Annex 176A naming (comments #196, #577 against D1.0)

IEEE P802.3dj interim meeting
14th May 2024

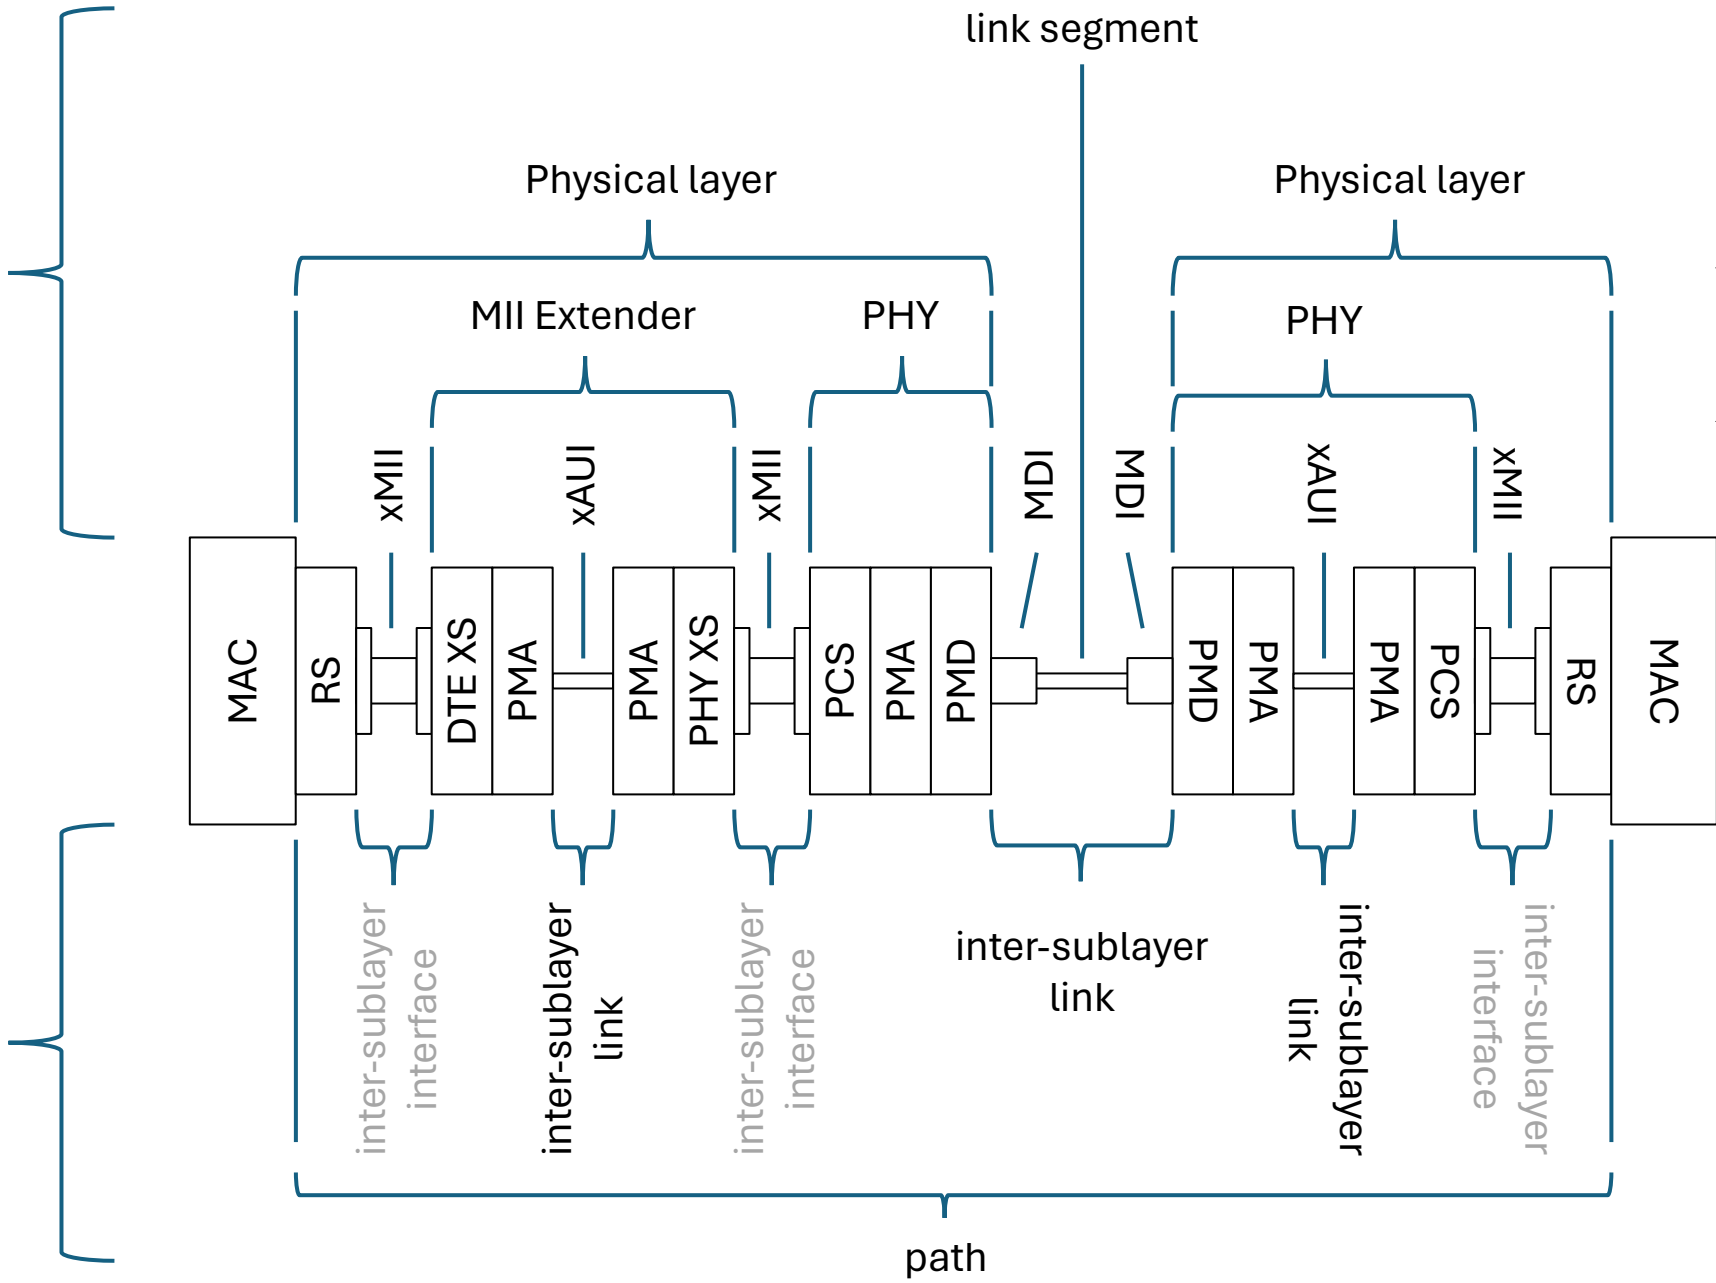
Suggested terms

PMD startup protocol
 ↓
 Inter-sublayer link PMD startup (ILS) protocol
 or
 Inter-sublayer link PMD startup training (ILT) protocol
